# SQUEAKING NOISE FROM SUBFRAME BUSHINGS / REINFORCEMENT PLATE

**NO:** TJ 17644

**ISSUE DATE:** JULY, 15, 2013

\*NOTE! THIS DOCUMENT SUPERSEDES THE PREVIOUS RETAILER TECHNICAL JOURNAL 17644 DATED 08-22-2012.

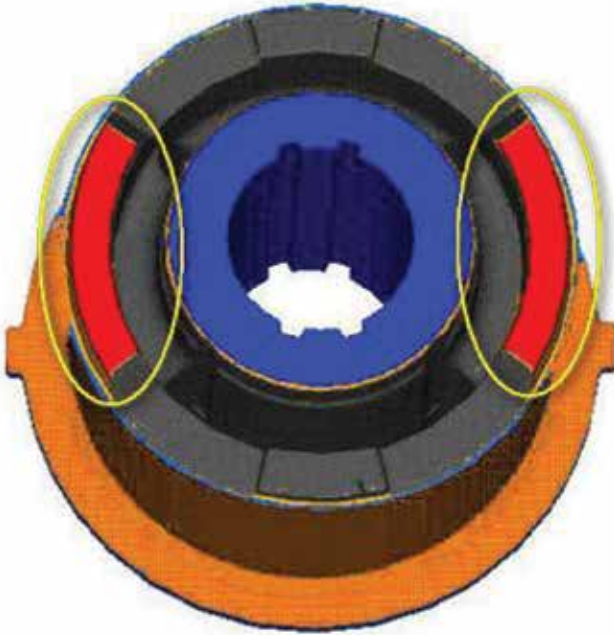
If this customer's complaint is verified, replace both right and left side reinforcement plates, refer to image "TJ17644: Contact Points," on the next page.

Torque specifications can be found on the next page, "TJ17644: Torque Specifications."

# TJ17644: CONTACT POINTS

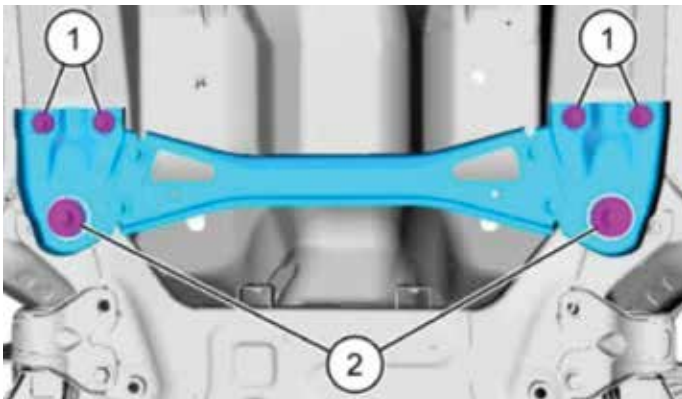
The noise usually comes from the rear bushings in the front subframe due to axial travel resulting in a rubbing or squeaking noise between the reinforcement plate and the bushings' front and rear axial movement limiters.

Once the rubber material on the bushing is worn out, the underneath plastic material may cause a soft knocking noise instead. The contact points are illustrated in the attached pictures: TJ 17644 -1.jpg; TJ 17644 -2.jpg

ORANGE BUSHING

BLUE BUSHING
